**PUBLIC INTEREST REVIEW FOR GROUND WATER APPLICATIONS**

**TO:** Water Rights Section **Date** 16 September 2016  
**FROM:** Ground Water/Hydrology Section Gerald H. Grondin  
Reviewer's Name  
**SUBJECT:** Application G-17985 Supersedes review of 18 June 2015  
Date of Review(s)

**A. GENERAL INFORMATION:** Applicant's Name: Surprise Valley Electrification Corp County: Lake

## Transmissivity from LAKE 1628 Specific Capacity Data

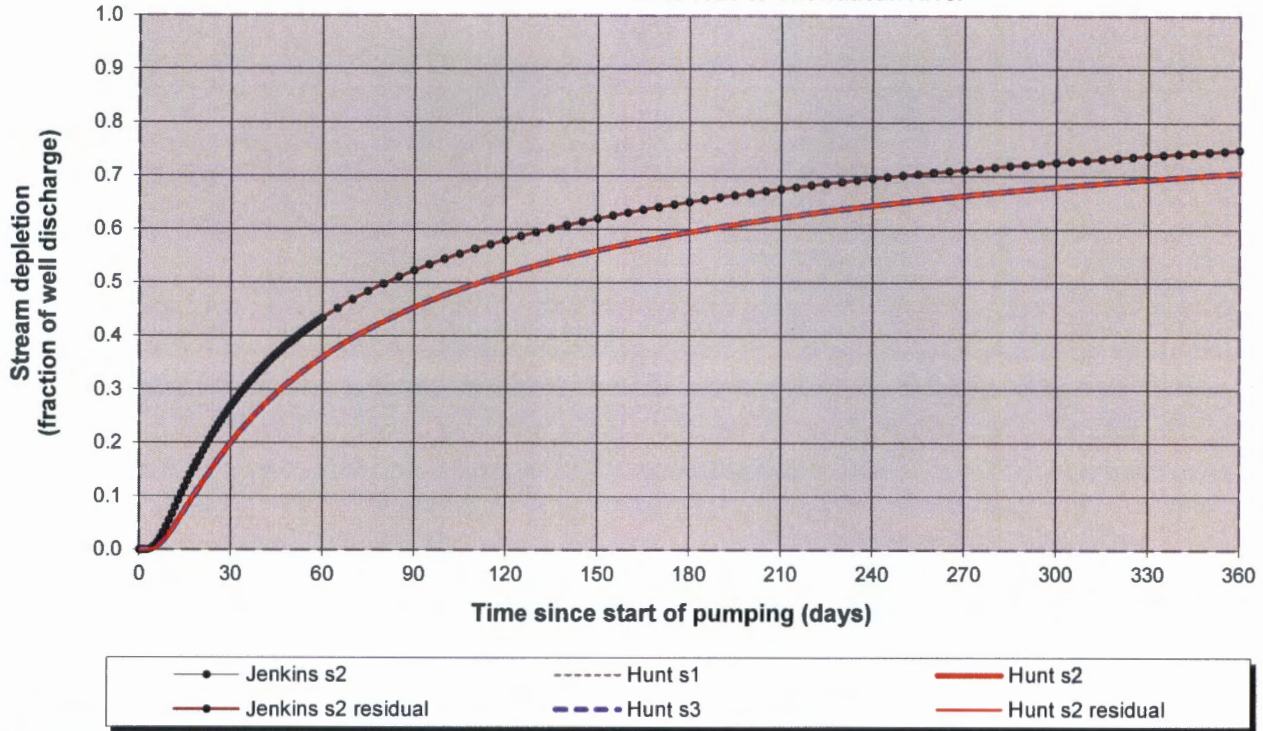
The calculated interference with the river at the end of 30 days is less than 25 percent based upon a test and analysis conducted by GSI for the applicant and subsequently reviewed by OWRD. The percent interference is independent of the pumping rate (the same for any pumping rate). The OWRD review is attached.

Hunt (1999) was used to calculate the interference with the Chewaucan River. The range of parameters used were a transmissivity range of 21.75 to 14,432.28 ft<sup>2</sup>/day based on the specific capacity data related to the proposed POA well and the test conducted by GSI, an intermediate storage coefficient of 0.001 was used for transmissivity derived from the test pumping well and transmissivity derived from specific capacity, a test derived storage coefficient range of 0.008 to 0.496 was calculated from the test observation well data and was used for the range of transmissivity derived from the same data, a stream width of 50 feet average, a streambed conductivity of 0.30 feet/day, a streambed thickness of 20 feet (a thicker streambed given this is a river), and the distance to the river where hydraulic connection occurs (5,000 feet) rather than the distance to the nearest river reach (950 feet).

GSI Surprise Valley Electric Pump Test (Water Right File G-17985)  
LAKE 52506 Water Level Drawdown Data (Jacob's Time versus Drawdown)

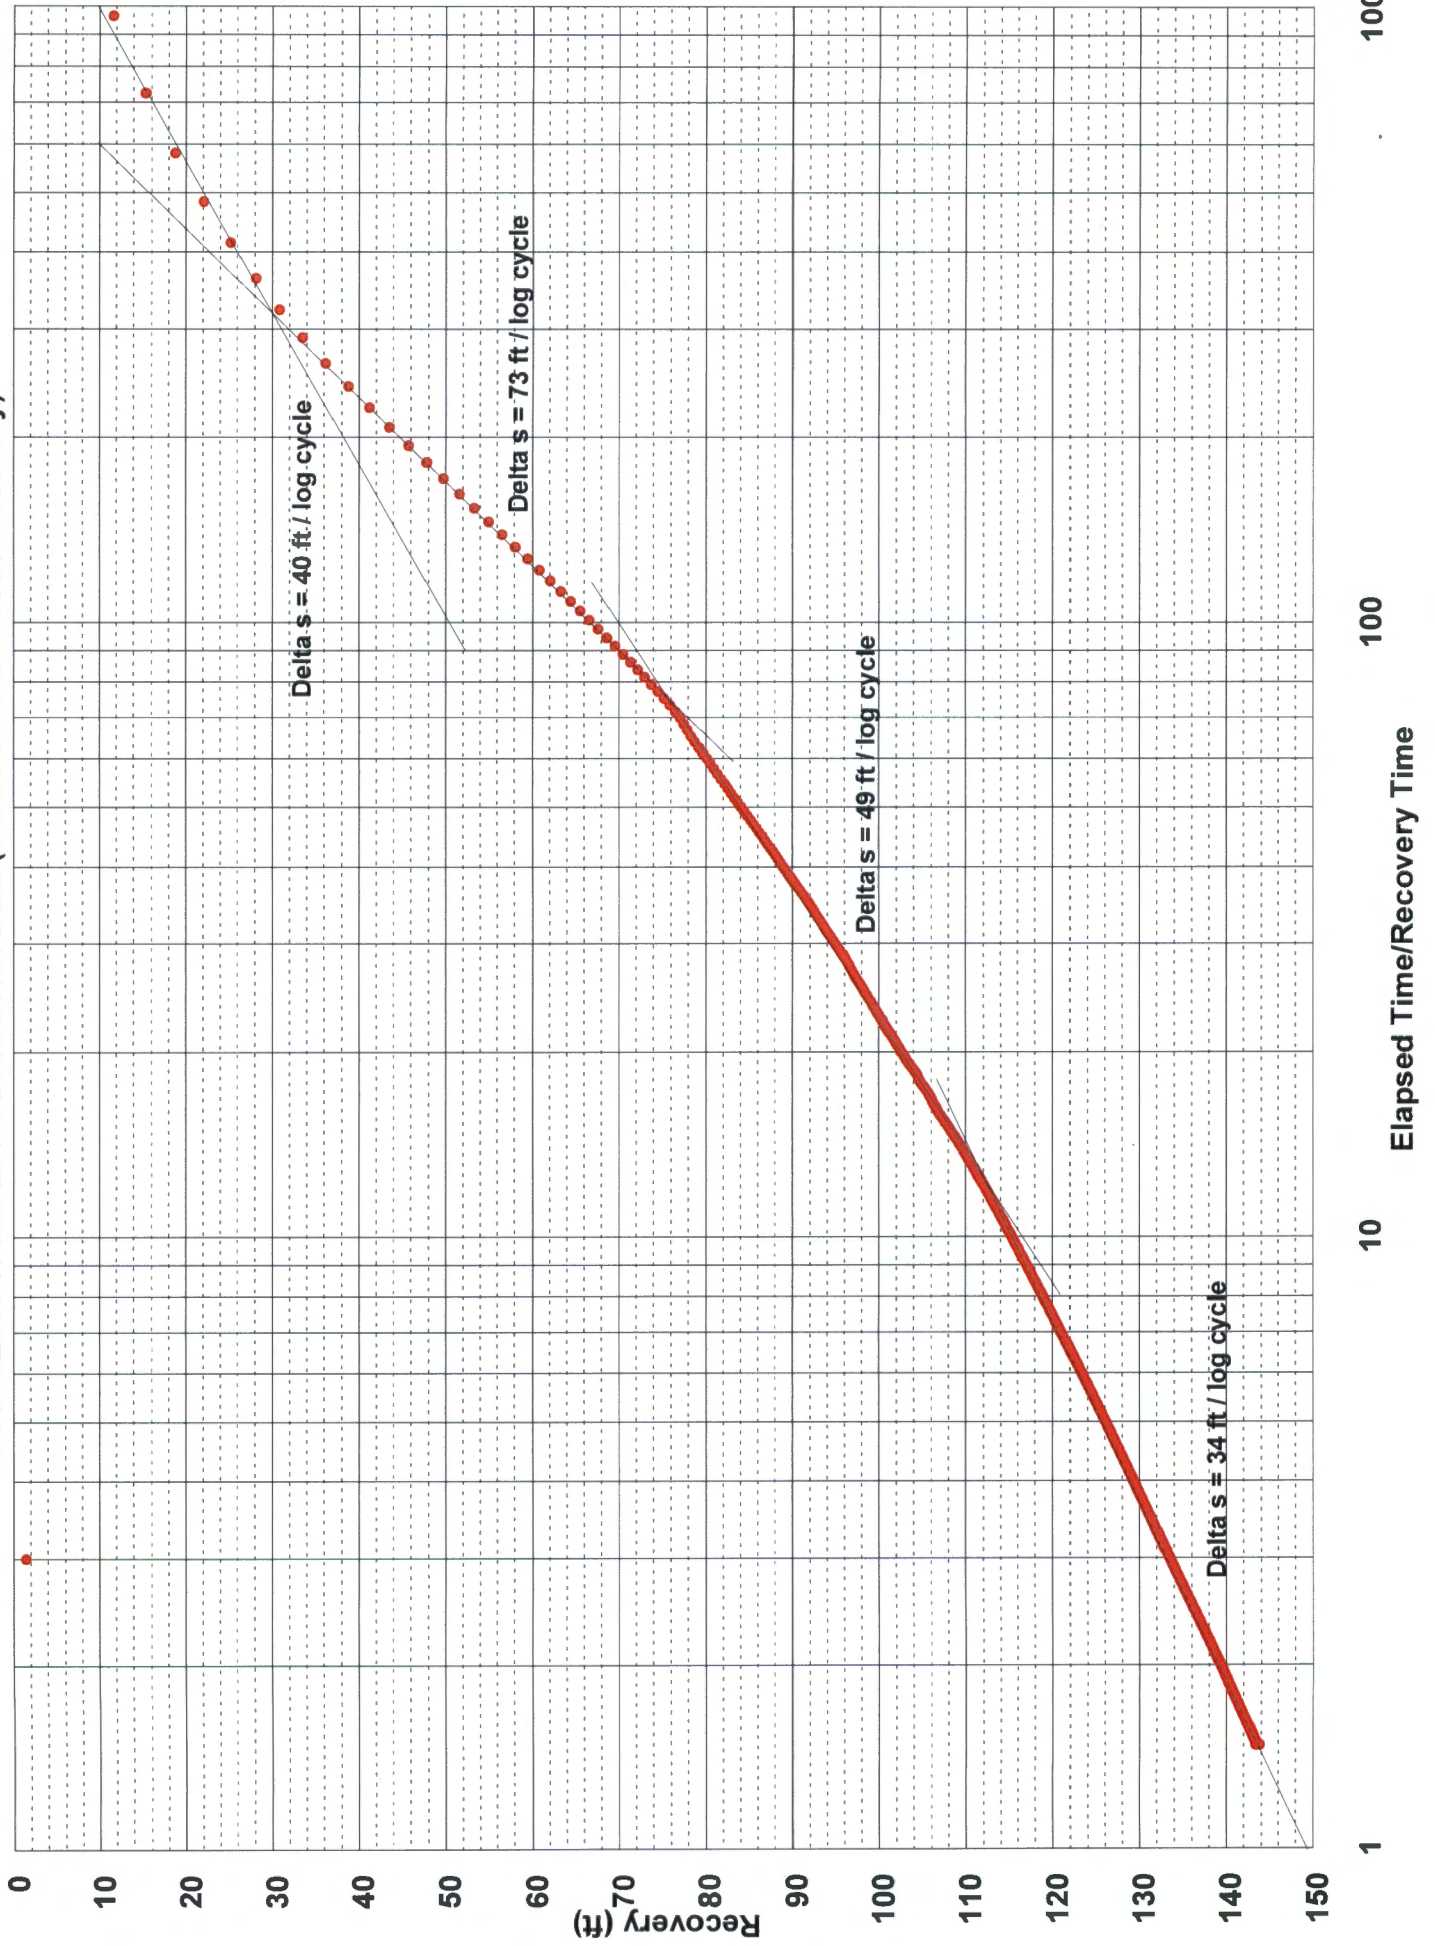
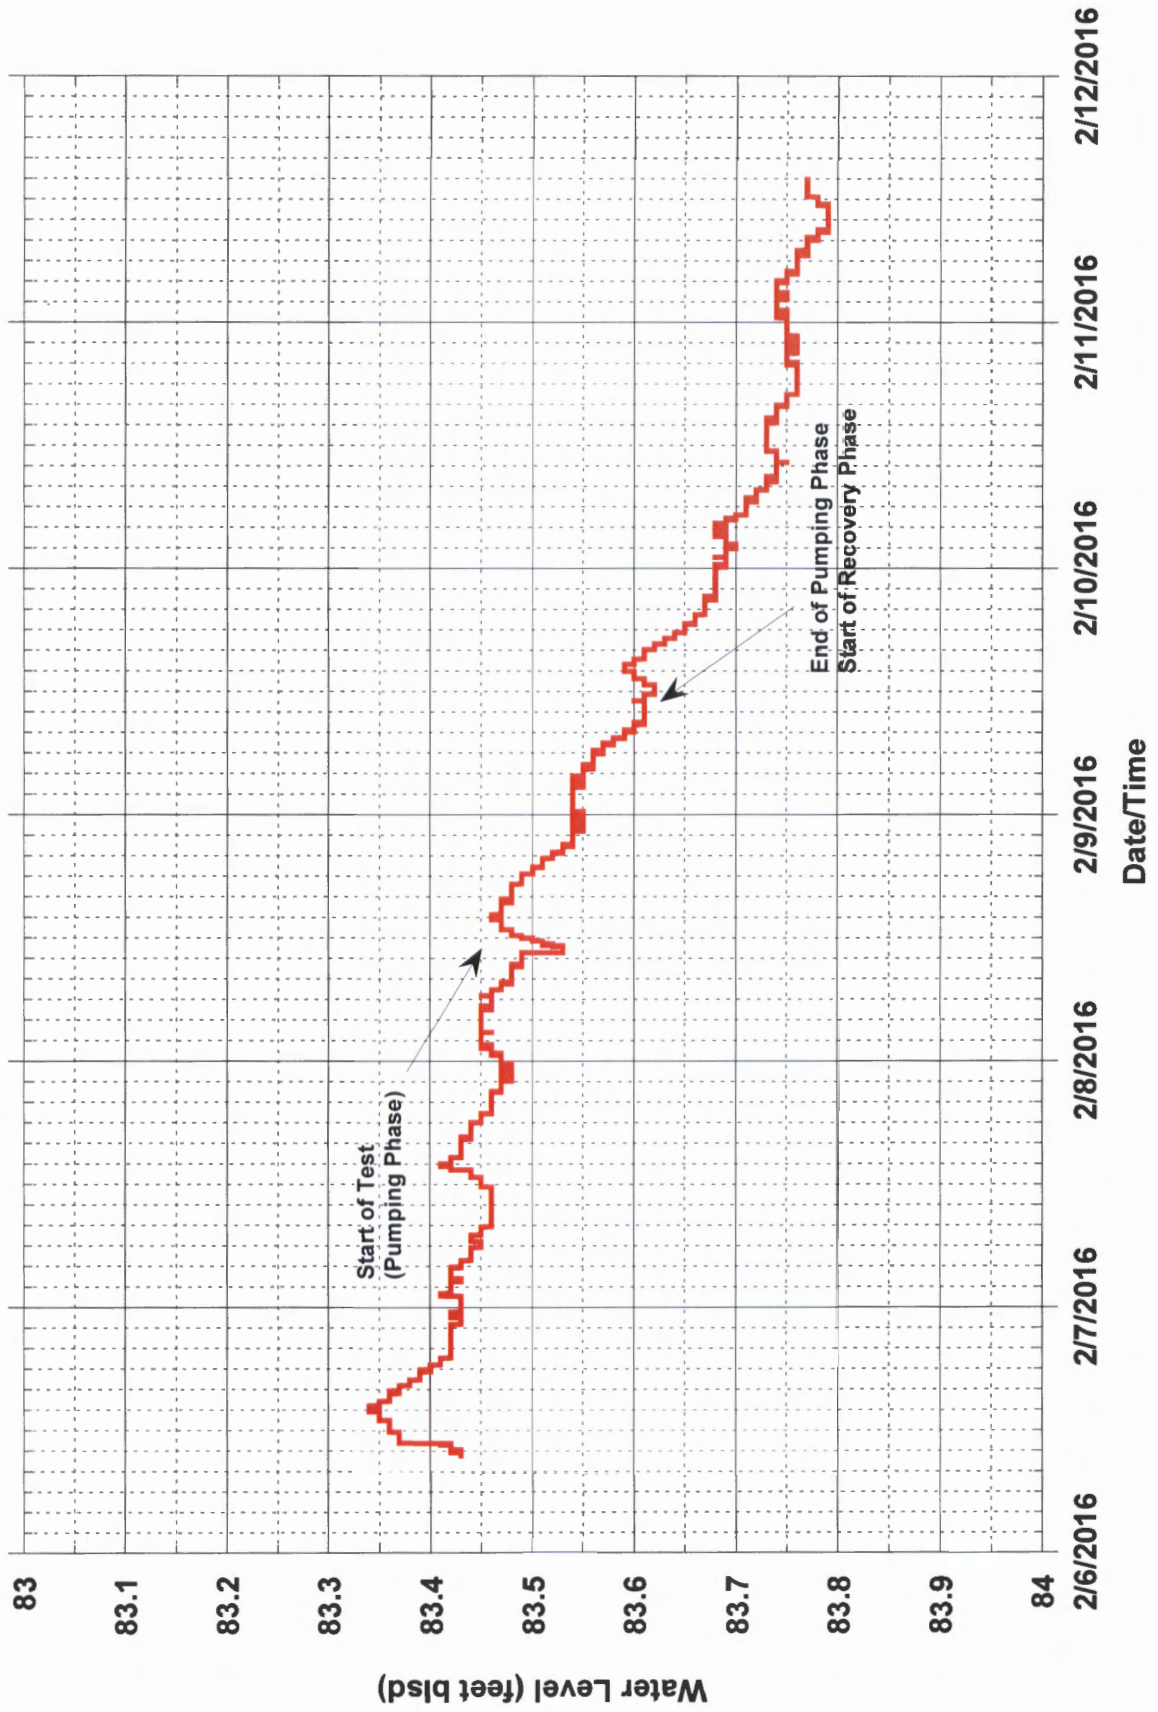
- The plotted data show boundary-like influences. The test complications preclude determining true boundary and/or delayed yield influences.

The transmissivity results for each well differ by orders of magnitude. The transmissivity and storage coefficient values for the non-pumping observation well LAKE 52683 ranged two to three orders of magnitude respectively. That is likely due to the small water level change at the well during the test allowing the various complications to have a greater influence. The transmissivity values calculated for the test's pumping well LAKE 52506 show a small range likely due to significant water level change at the well dwarfing the influence of the various complications.
